ENGINE – PROVIDE A SEAL FOR THE BOOSTER STAGE BLEED VALVE A/O AND A REPLACEMENT LPC
INLET GUIDE VANE ASSEMBLY – CATEGORY CODE 7 – MOD.ENG-72-0031

V2500-ENG-72-0031

SERVICE BULLETIN

Booster stage bleed valve A/O before and after alteration
Fig.1

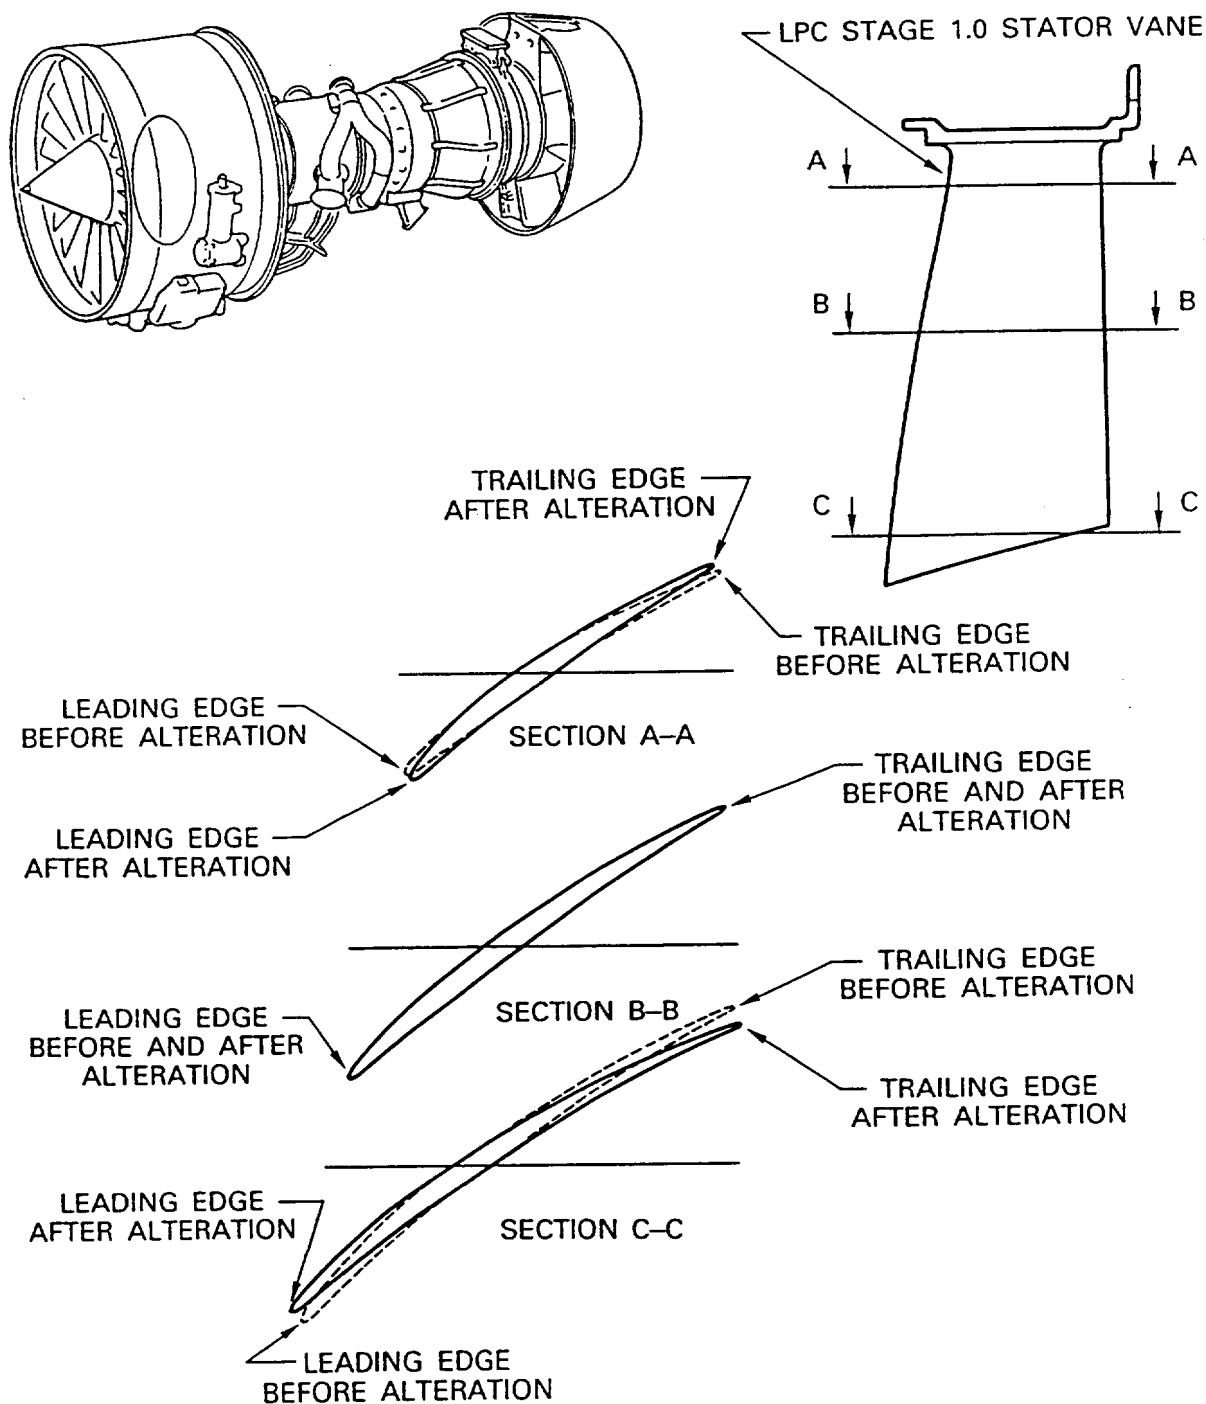
- (a) The LPC booster stage bleed valve A/O which has the front rubber seal, has been reintroduced as a performance benefit. (See Figure 1.)

LPC inlet guide vane assembly before and after alteration
Fig.2

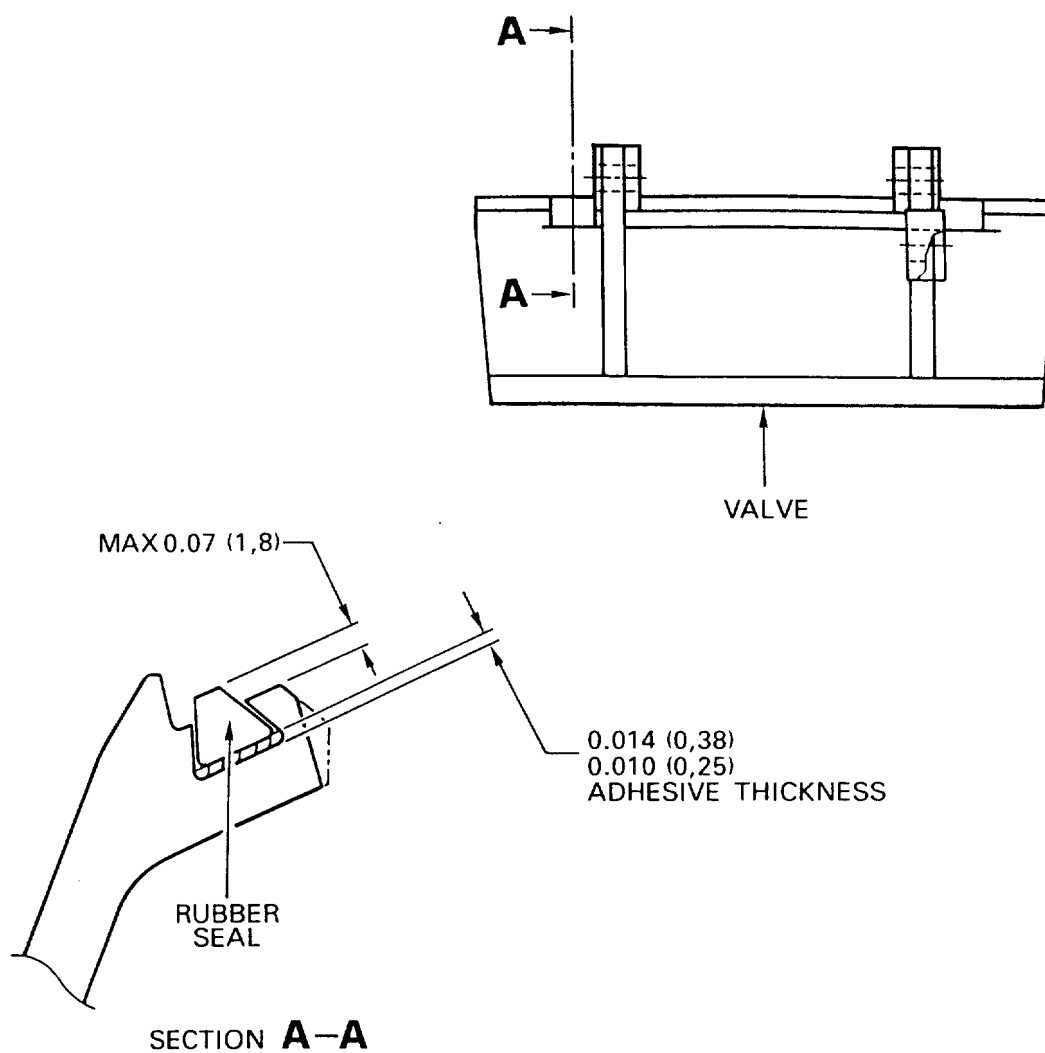
- (b) A new LPC inlet guide vane assembly which has the redesigned airfoil profile of the vane leading and trailing edge angles, has been introduced to improve the surge margin. (See Figure 2.)

Rework the valve assembly
Fig.3 (sheet 1)

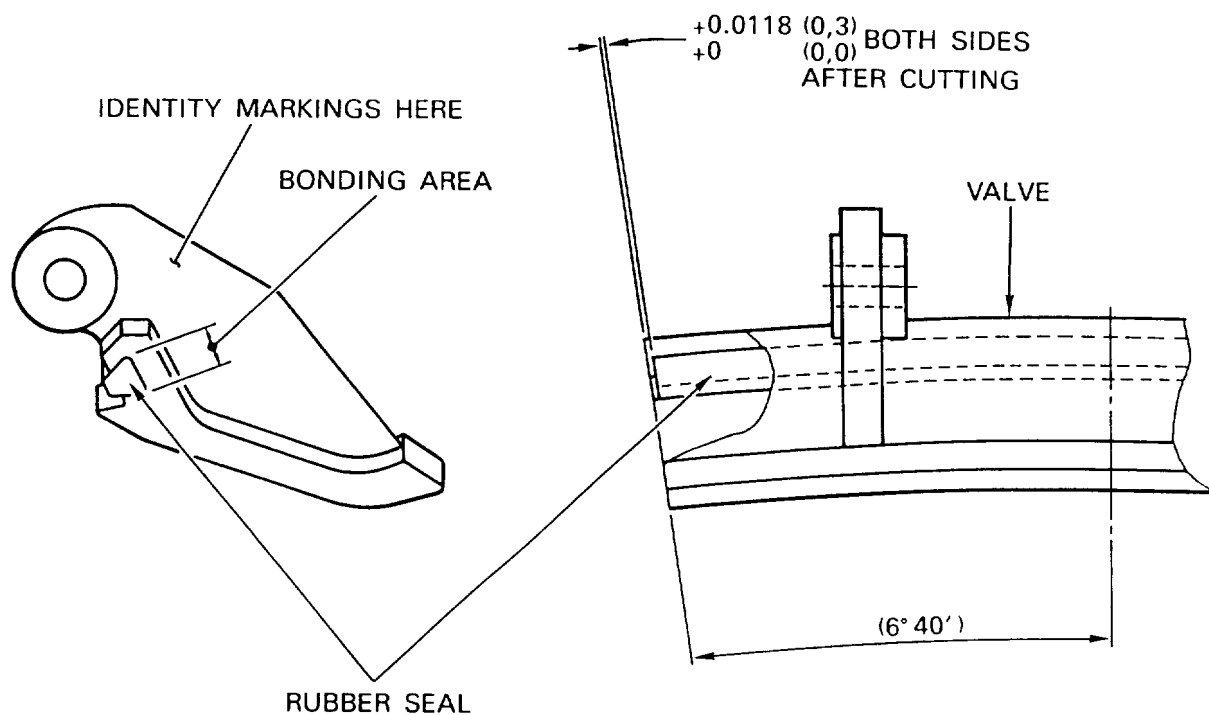
Procedure	Supplementary Information
(a) Prepare the mating surfaces for the cold curing silicone rubber compound	Refer to Figure 3 (sheet 1) and Engine Manual, TASK 72-32-72-300-002, VRS1334

(b) Apply the surface protection to the valve assembly	Refer to Figure 3 (sheet 1) and Engine Manual, TASK 72-32-72-300-002, VRS1334
CAUTION: 1. DO NOT EAT ANYTHING OR SMOKE AT LOCATION WHERE THESE MATERIALS ARE USED.

2. AFTER PREPARATION THE MATING SURFACES MUST BE FULLY CLEANED AND MUST NOT BE TOUCHED BY HAND TO PREVENT CONTAMINATION.	
(c) Apply and cure the cold curing silicone rubber compound	Refer to Figure 3 (sheet 1 and 2) and Engine Manual, TASK 72-32-72-300-002, VRS1334
